SYSTEM 80

CESSAR. FSAR

DOCKET STN 50-470

RESPONSES TO QUESTIONS ON CESEC

FIGURE 440.85-1
STEAM GENERATOR
INITIALIZATION

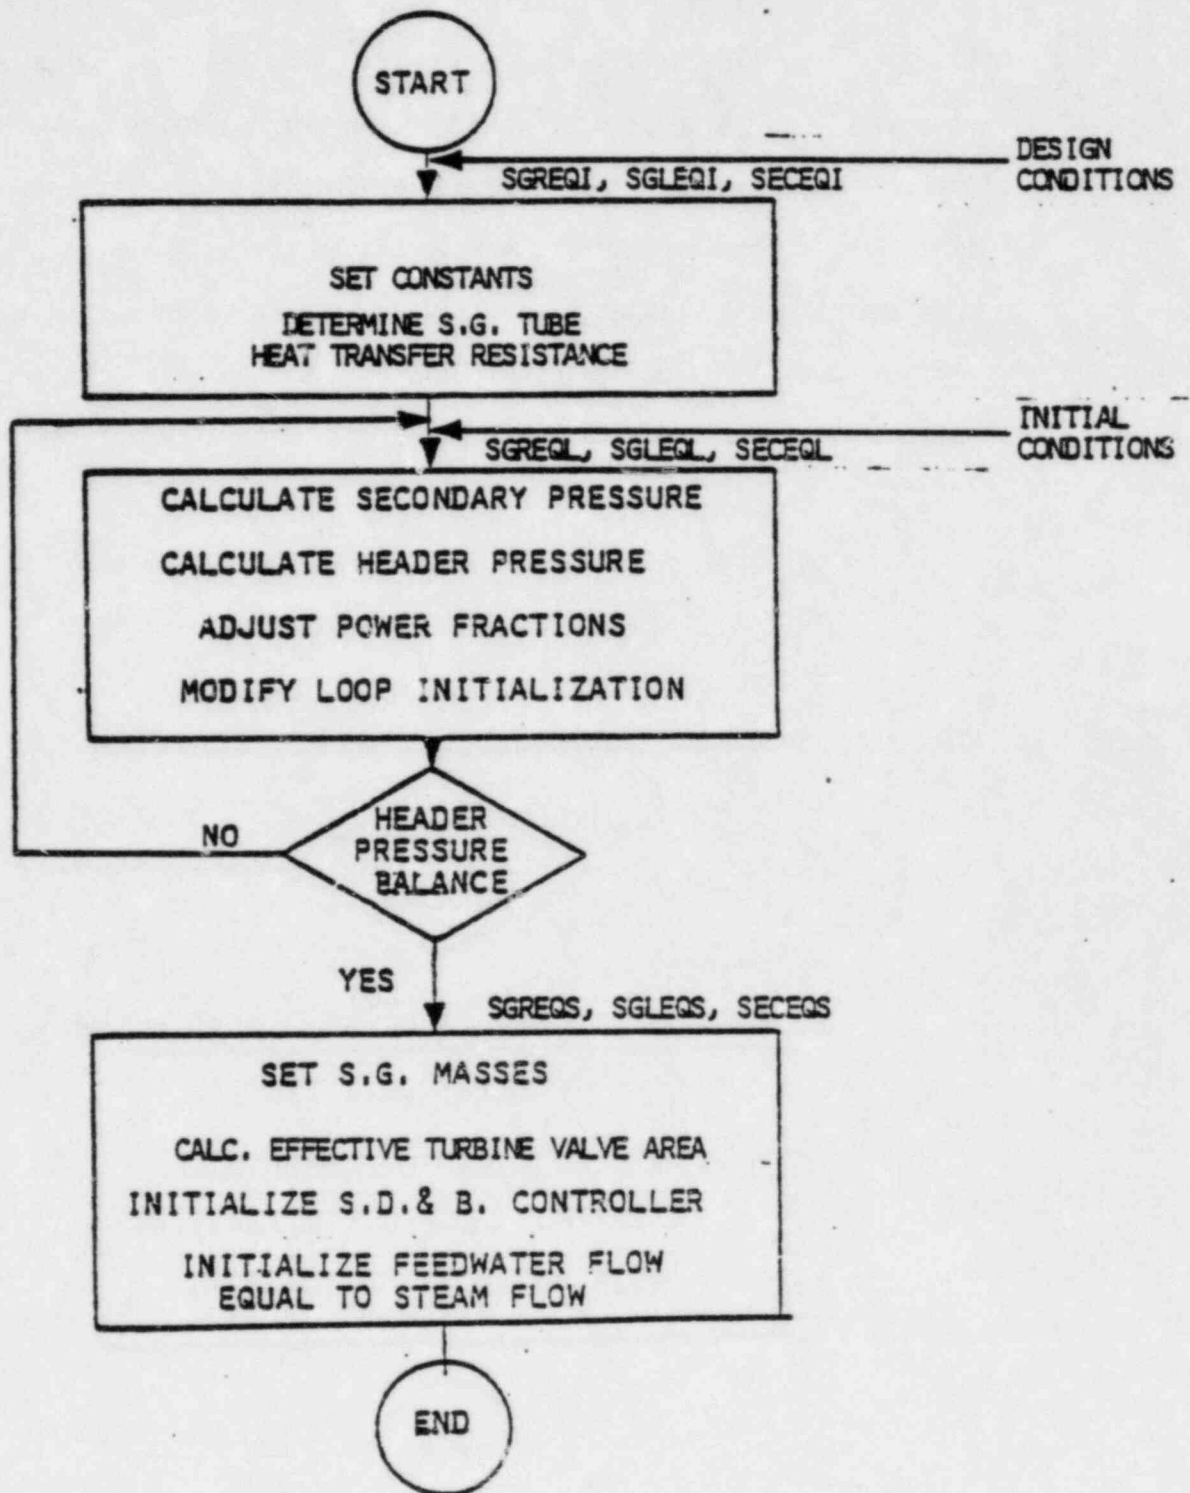
440.85 Describe the self-initialization procedure.
(440.3)

The subroutine STEADY serves as a calling subroutine which coordinates the self initialization process and input data loading in CESEC-III. The reactor system modules are called to set up their input information and to define their initial conditions at time zero. The CESEC code can be initialized at any combination of reactor power level, reactor coolant system flow rate, and steam generator power sharing. Since some of the main steam system parameters are mutually dependent on one another (i.e., PSECR, PSECL, PHEAD, etc.) an iteration process is used among subroutines SGLEQL, SGREQL, and SECEQL to find their equilibrium initial conditions. The calling sequence in STEADY is as follows:

Figure 440.85-1 details the above steps in block diagram form. The loop at the center of this diagram shows the iterative procedure used to arrive at values for power sharing. Steam line pressure loss is accounted for during this iterative procedure for solving for power sharing. The effective flow loss coefficient for the piping modeled in the header simulation equations (see Figure 15-1A of Ref. 13) is used to calculate the header pressure that would result from the pressure in each steam generator and the steam flow from that generator due to the heat transfer from primary to secondary (i.e., power) in that generator. Iteration is continued until the resultant header pressure calculated from the pressure and steam flow of one generator equals that for the other.

*Figure 440.85-1 is a flow diagram of steps d, e, and f.

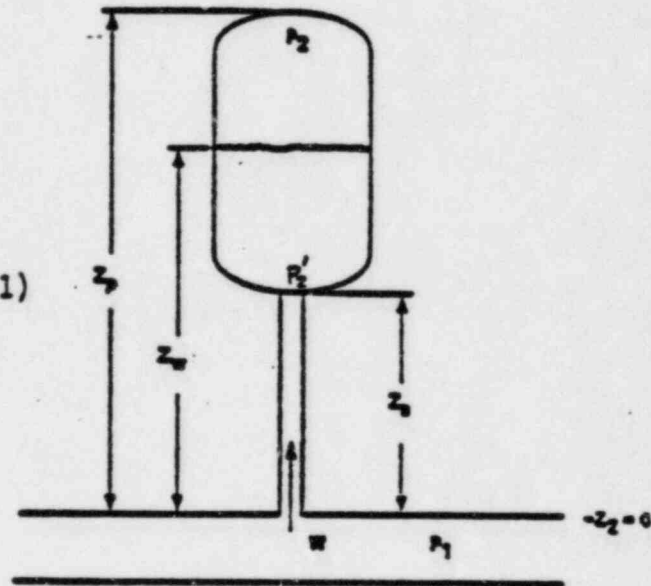
440.92 Why does the gravity term in the surge line momentum equation, eq. (440.10) (7.1) contain expressions for the pressurizer when the inertia term is written only for the surge line?

The surge line momentum equation can be written as (see Figure 440.92-1).

$$P_2' - P_2 = \frac{\rho_w}{144} (Z_w - Z_a) + \frac{\rho_s}{144} (Z_p - Z_w) \quad (2) \quad \text{Figure 440.92-1}$$

Therefore, substituting Equation (2) into Equation (1) for P_2' yields Equation (7.1).

The (L/A) in the inertia term is written in terms of the surge line since the L/A for the pressurizer is small compared with the L/A for the surge line.

Figure 440.95-1
Basic geometry of wall heat model

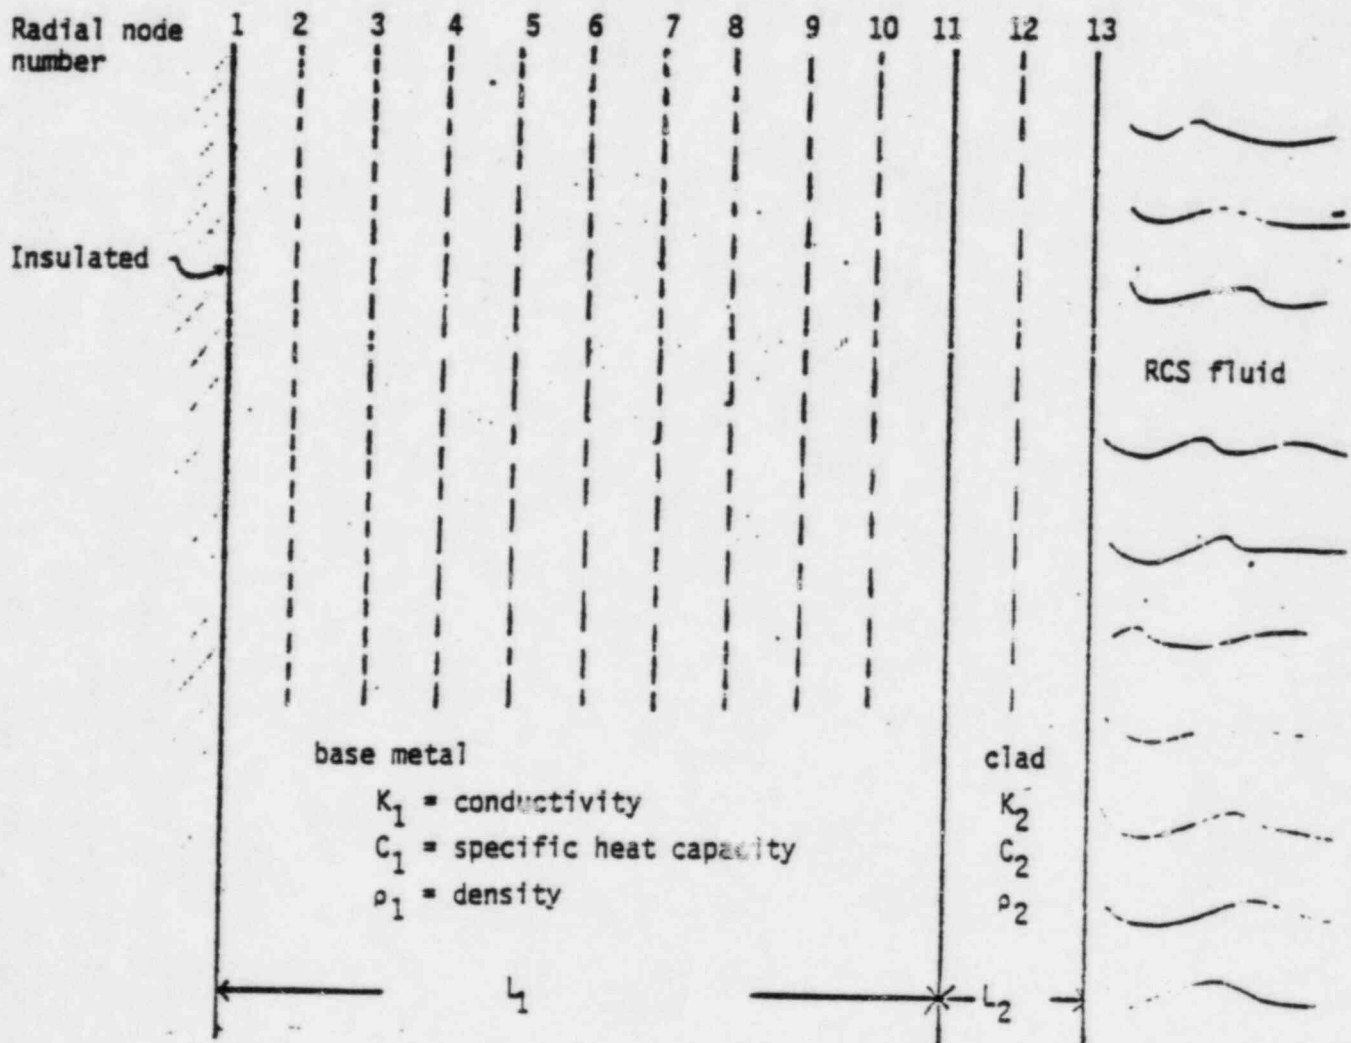
440.95 Are the 13 nodes referred to in the wall heat transfer model radial
(440.13) nodes? Provide a figure for the model to illustrate it.

The 13 nodes are referred to in the wall heat transfer model are radial nodes. Figure 440.95-1 presents the basic geometry of the wall heat model in the thermal hydraulic node.

FIGURE 440.109-1
 REYNOLDS-NUMBER FACTOR
 VS
 RECIPROCAL MARTINELLI PARAMETER

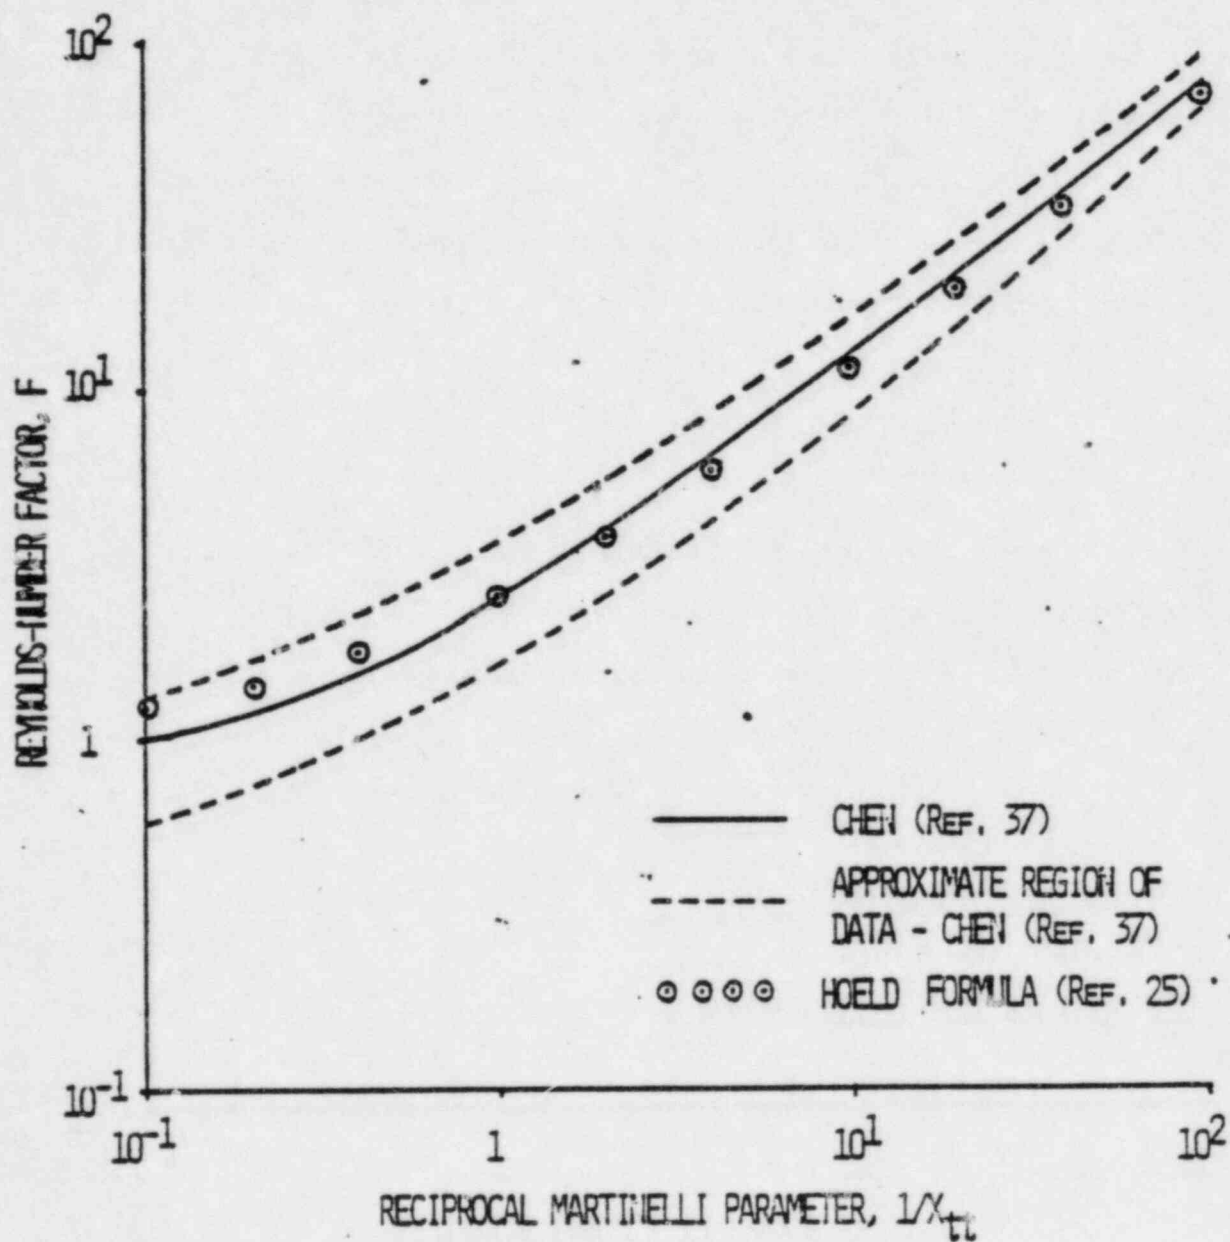
- 440.109 (a) Why does the suppression factor S , given by eq. (13-9) not
(440.27) correspond with the formula given in Table 2 of the Hoeld+
paper referenced?
- (b) Provide references/explanation for the difference in functional
dependence between Chen's suppression factor* $f(Re_p F^{1.25})$
and Hoeld's expression $f(1-x) Re_p F^{-1.25}$.
- (c) Justify the choice of Hoeld's formula for the Reynold's number
factor, F , eq. (13-8) over the original Chen values.

When the Hoeld functional fit is compared to the Chen data (Reference 37), reasonable agreement is observed (See Figure 440.109-1). For these reasons the Hoeld expression for the Reynolds-number Factor is used in the CESEC-III code.

FIGURE 440.150-1
CESEC FLOW PATHS FOR REACTOR VESSEL REGION

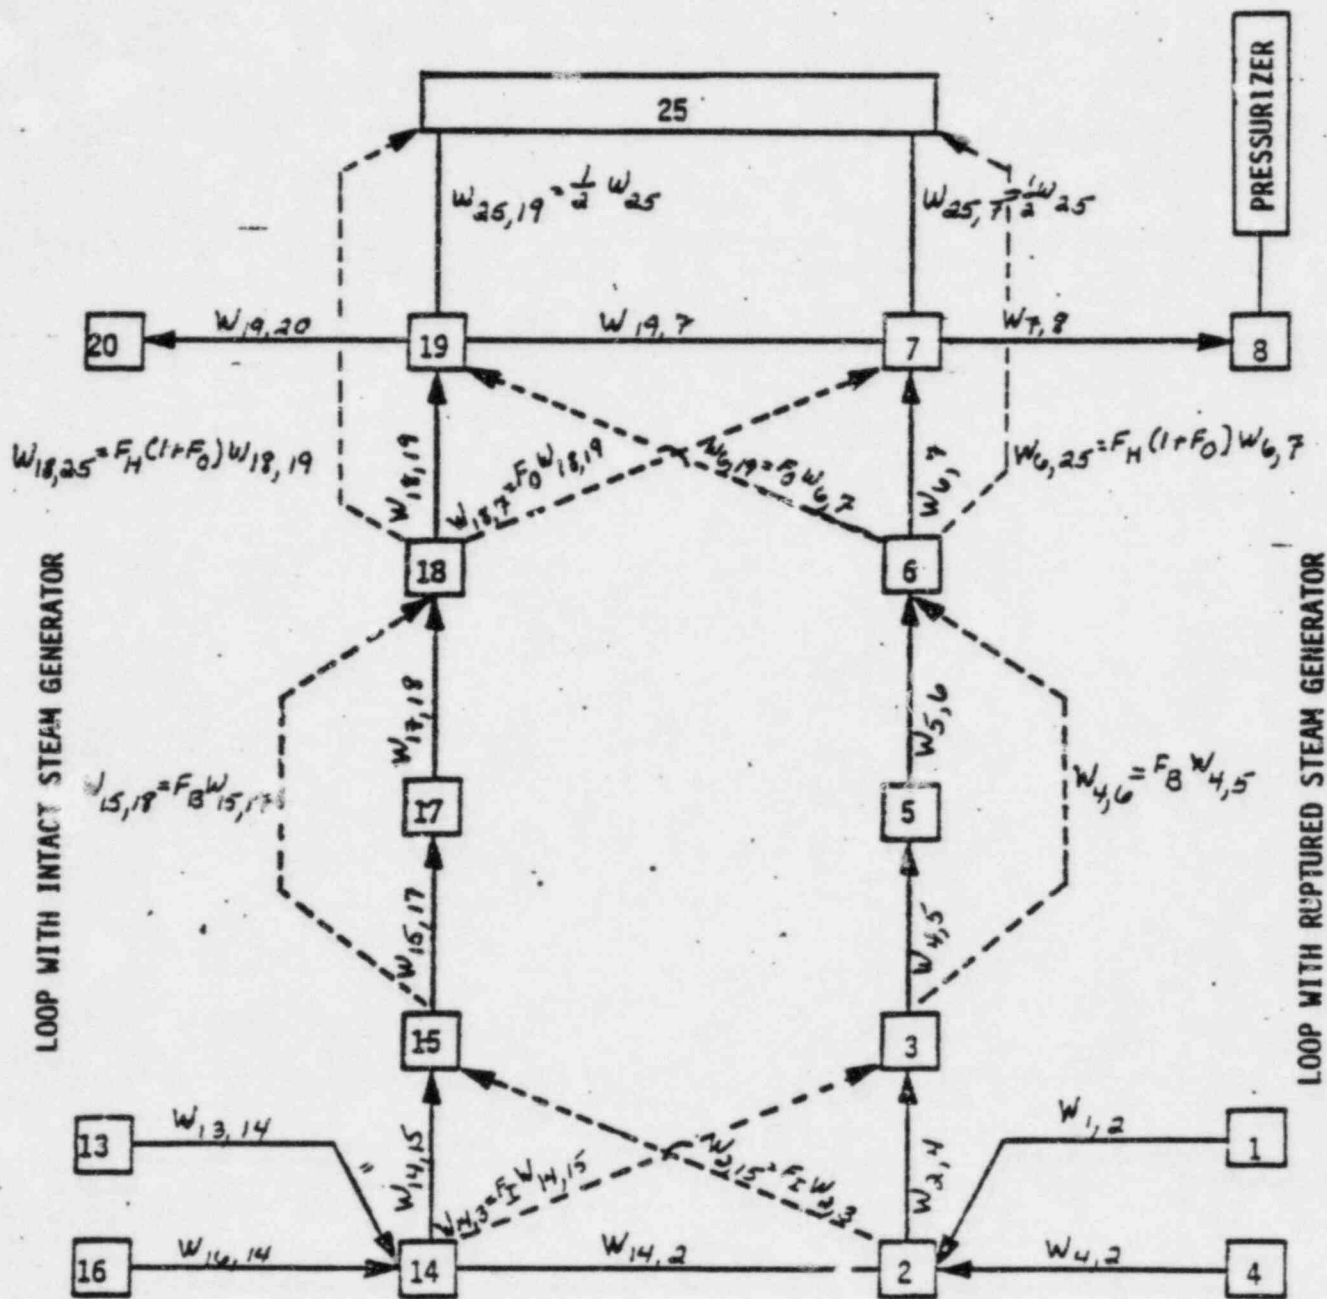
440.150 In general, it is our impression that the data⁽¹⁾ presented by
(440.68) FP&L is sufficient to support a general mixing model since only one
flow condition was measured. Furthermore, the particular flow
condition chosen has a Reynolds number nearly one full order of
magnitude below operating conditions.

Thus it is our general opinion that this single data point is not an
adequate basis upon which to build a computer code model intended to
model a wide range of flow conditions. The following specific
questions should be addressed by the applicant.

Figure 440.150-1 illustrates the flow paths in the CESEC model for the reactor vessel region. This figure is the same as the reactor vessel region of Figure 2-1 of the CESEC Report (Reference 13). The following discussion will focus on the "cross flows," $W_{14,2}$ and $W_{19,7}$ (or "density driven terms") and on the "mixing flows," $W_{2,15}$, $W_{14,3}$, $W_{6,19}$, and $W_{18,7}$ (or "hardwired terms"). The "cross flows," $W_{14,2}$ and $W_{19,7}$, are determined by direct solution of the thermal hydraulic equations (Eqns. 2-1 and 2-2) of Ref. 13). The "mixing flows" are calculated as described on p. 2-2 of Ref. 13 using experimentally determined mixing factors, F_I and F_0 :
